**Addendum No. 2  
January 19, 2024**

Project: **Lennox High School Addition**  
Lennox, South Dakota  
Architecture Incorporated Project No.: 2982

Architect: Architecture Incorporated

5.10

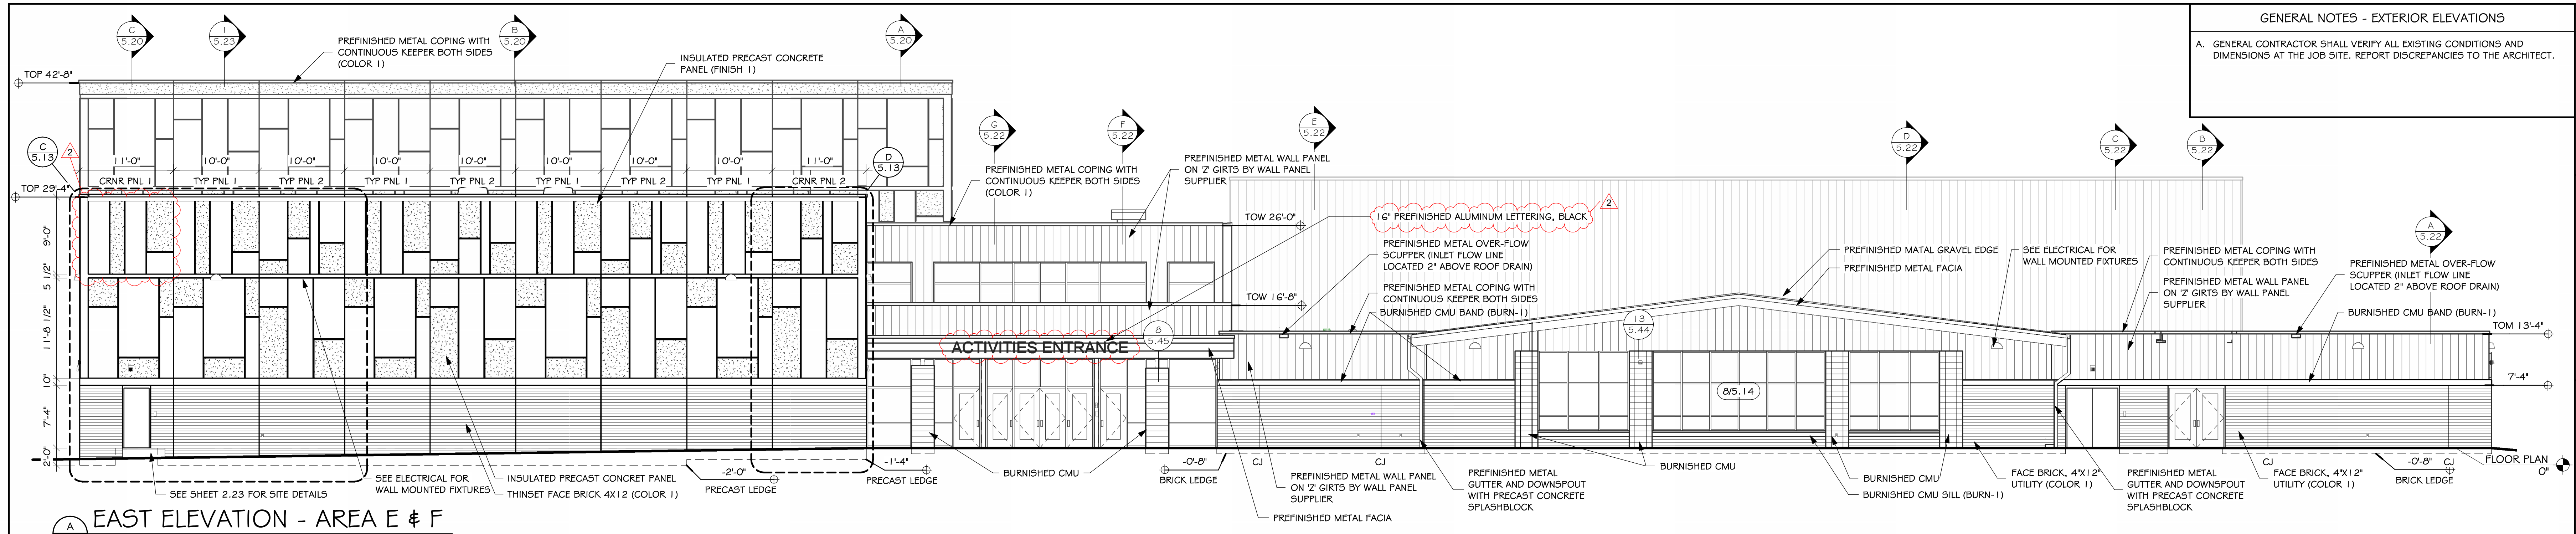
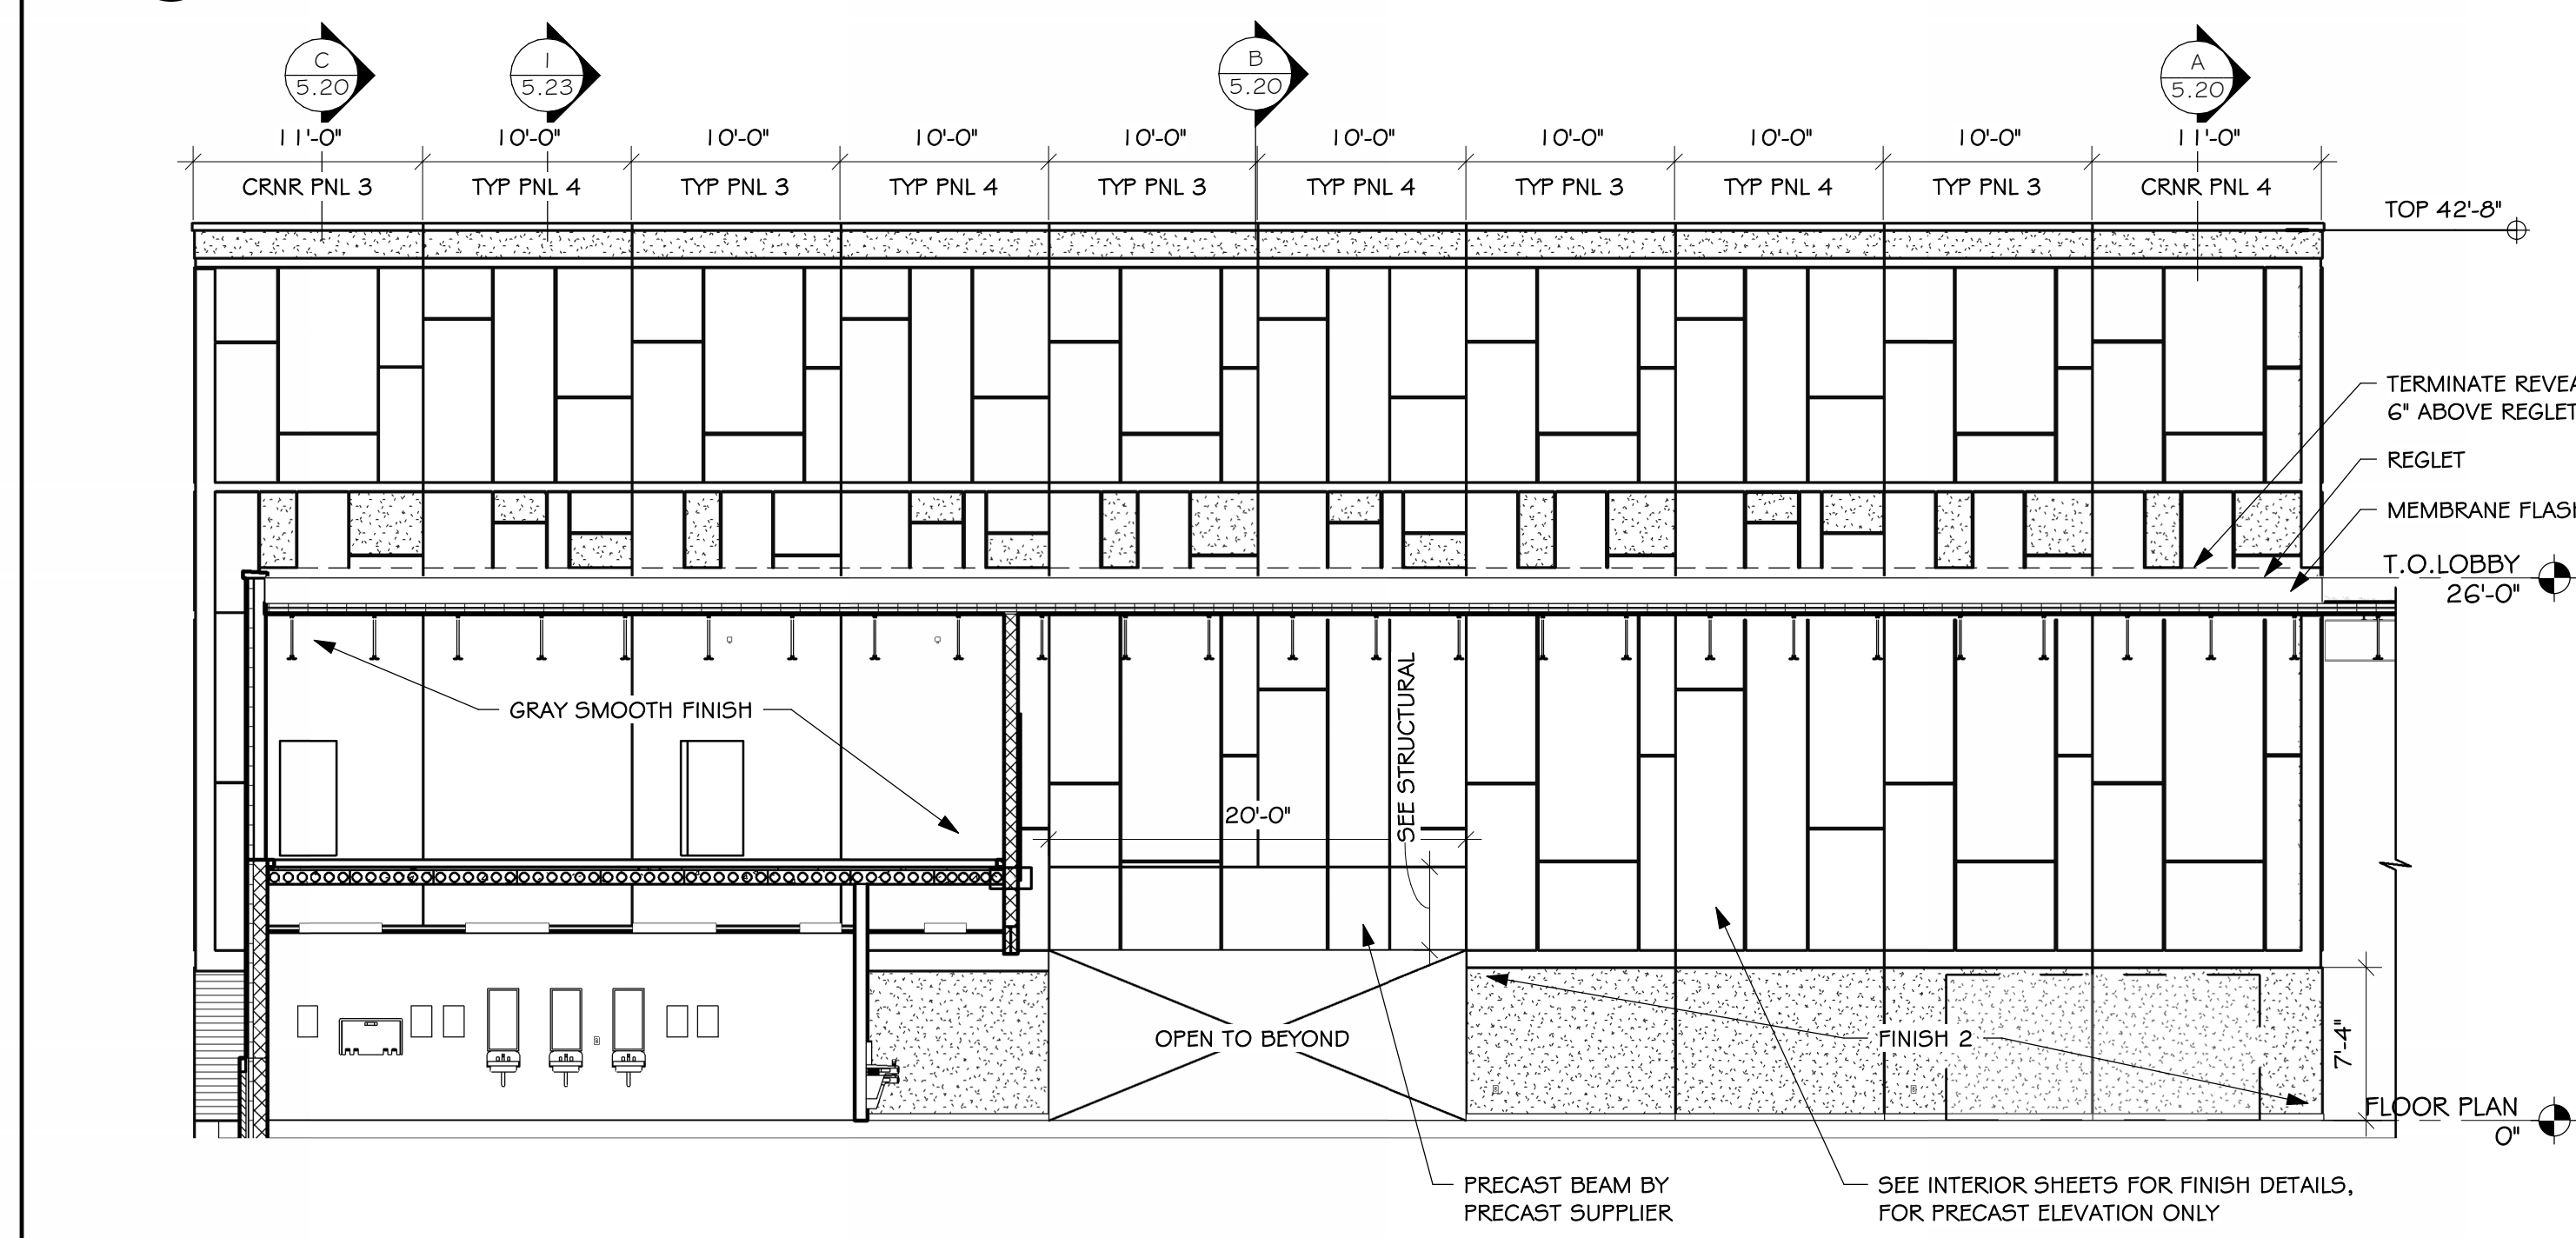
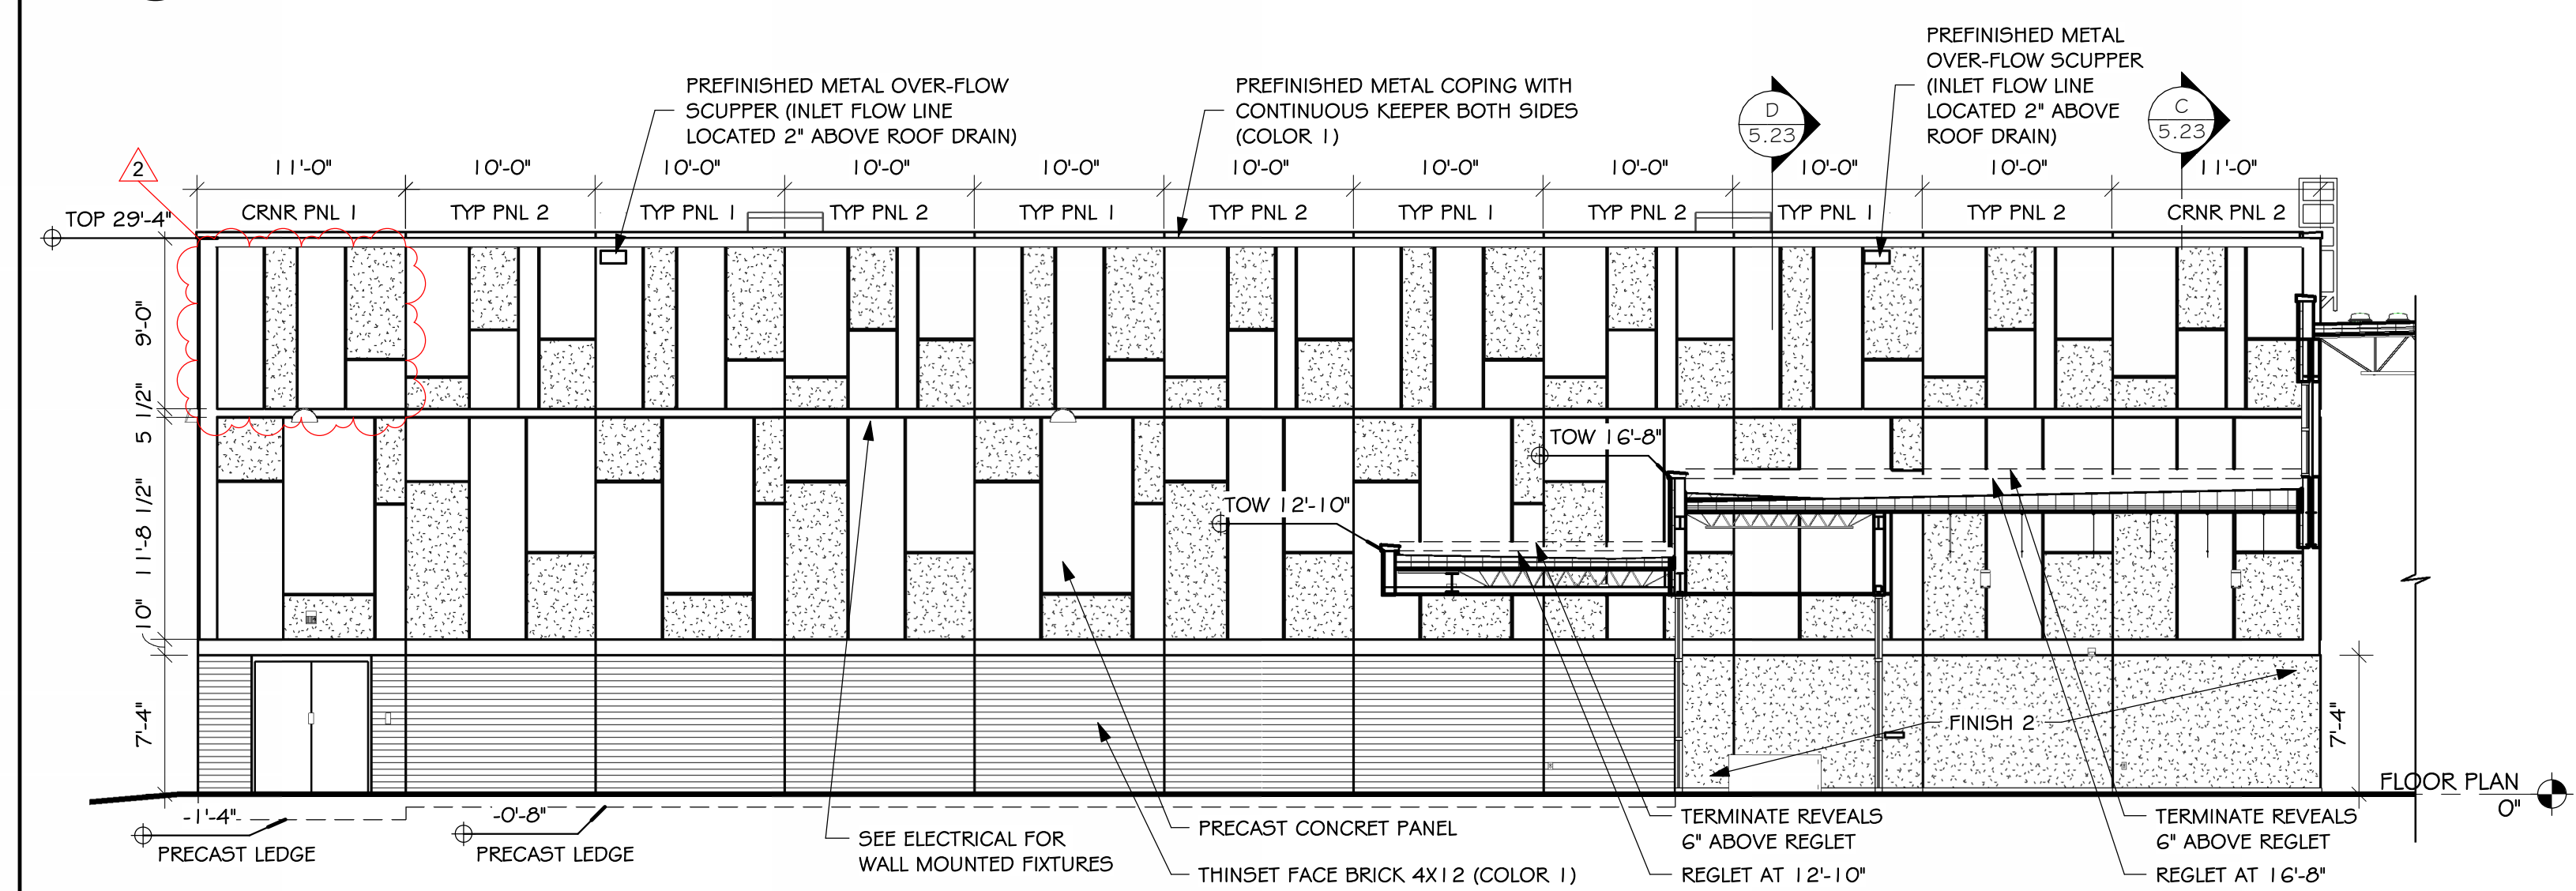
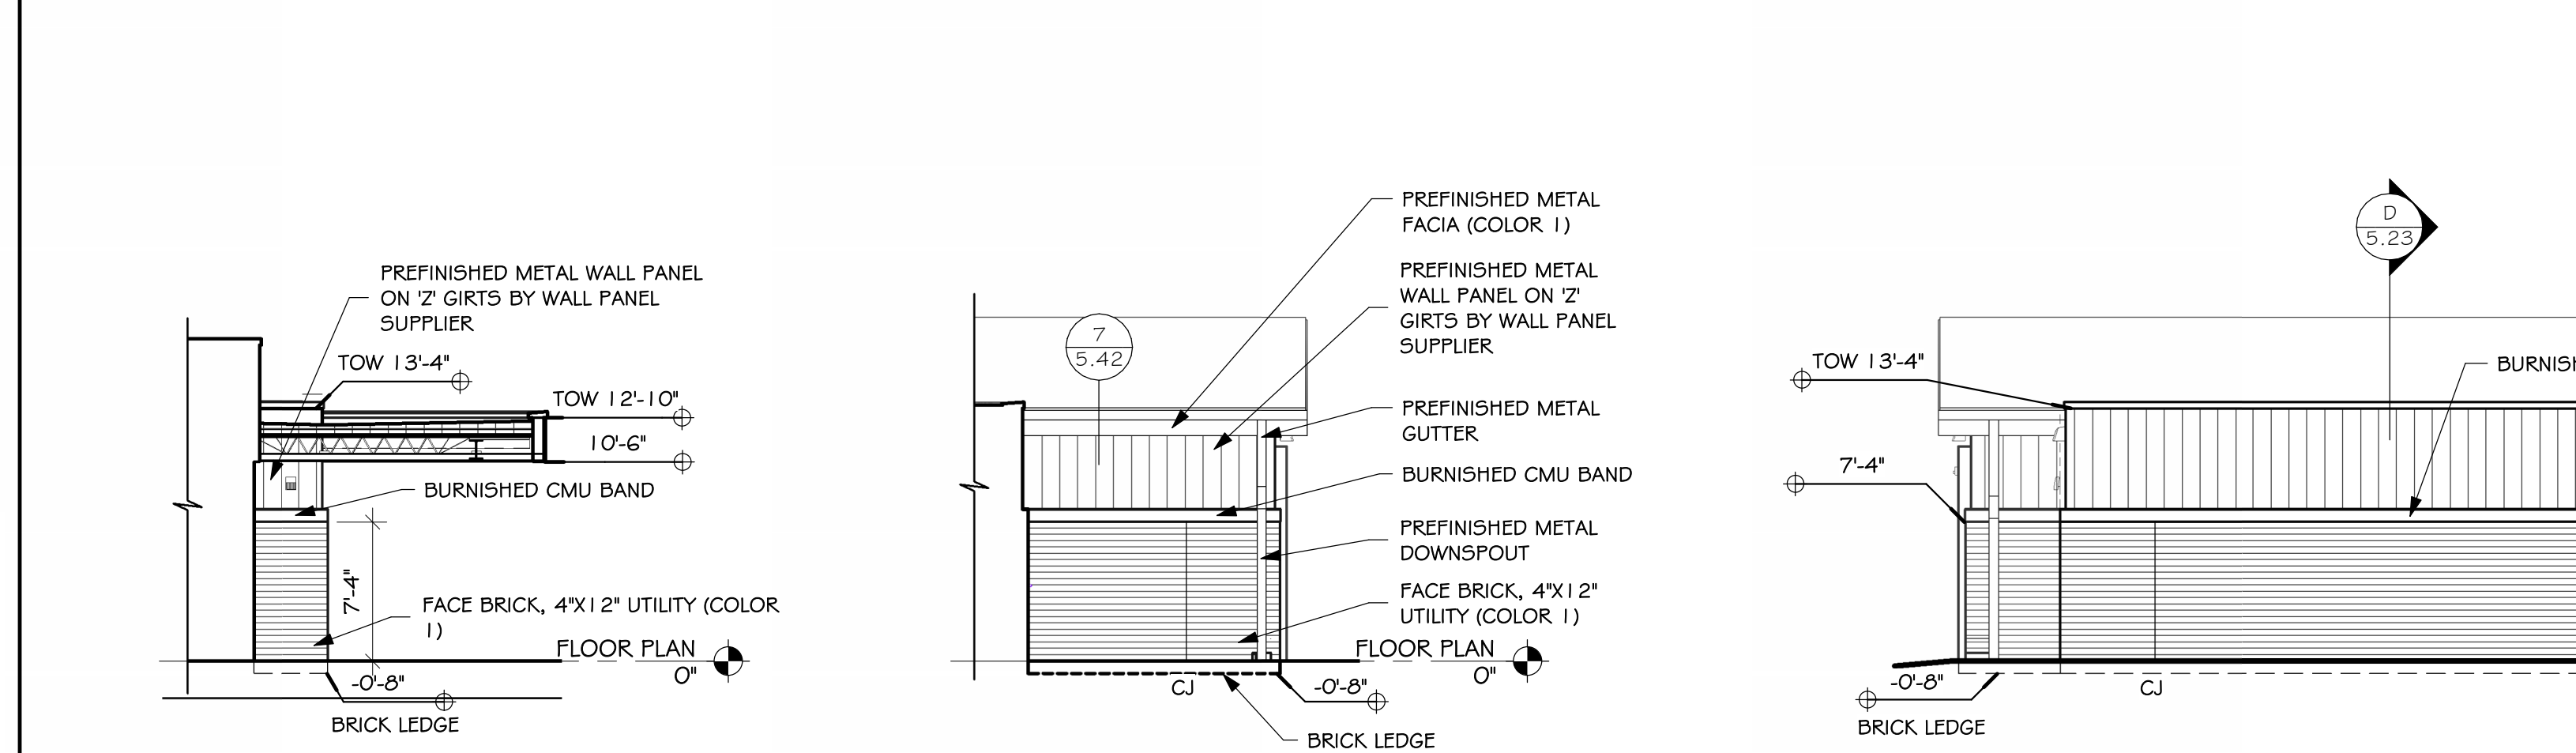
27) SHEET 5.10 – EXTERIOR ELEVATIONS

- a) Reference *revised* drawing Sheet 5.10, dated 1-18-24, attached to the end of this addendum for the following:
  - i. The exterior lettering shown above the new east entrance has been changed to read **“ACTIVITIES ENTRANCE”** in lieu of ACTIVITIES ENTRY.
    - 1. This exterior lettering shall be furnished and installed by the Contractor under his Base Bid.
    - 2. Reference Section 101419 “*Dimensional Letter Signage*”, dated 1-16-24, attached to the end of this addendum for product specification; 5 pages total.
  - ii. Corrections have been made with regard to the precast wall panel finish; reference exterior elevations A, B & C/5.10.
